■ FRAME

The frame is basically the same ladder type used in the previous model. The shape of the various areas of the frame has been revised in order to realize excellent collision safety performance and to improve riding comfort.

A-A Cross Section

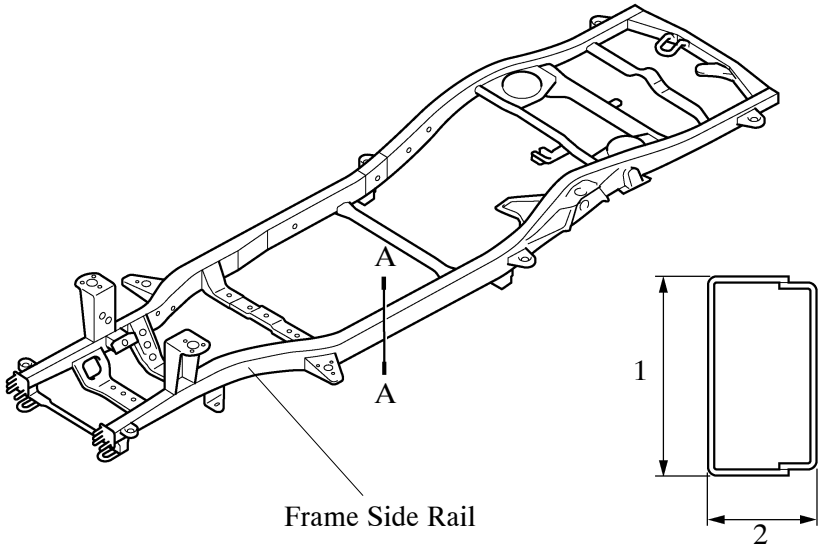
- The cross section area of the frame side rail has been enlarged in order to realize excellent frame's rigidity and joining rigidity of the suspension system. As a result, the vehicle's riding comfort has been improved.

Model / Item			New	Previous
1	Height	mm (in.)	160 (6.3)	140 (5.5)
2	Width	mm (in.)	85 (3.3)	70 (2.8)
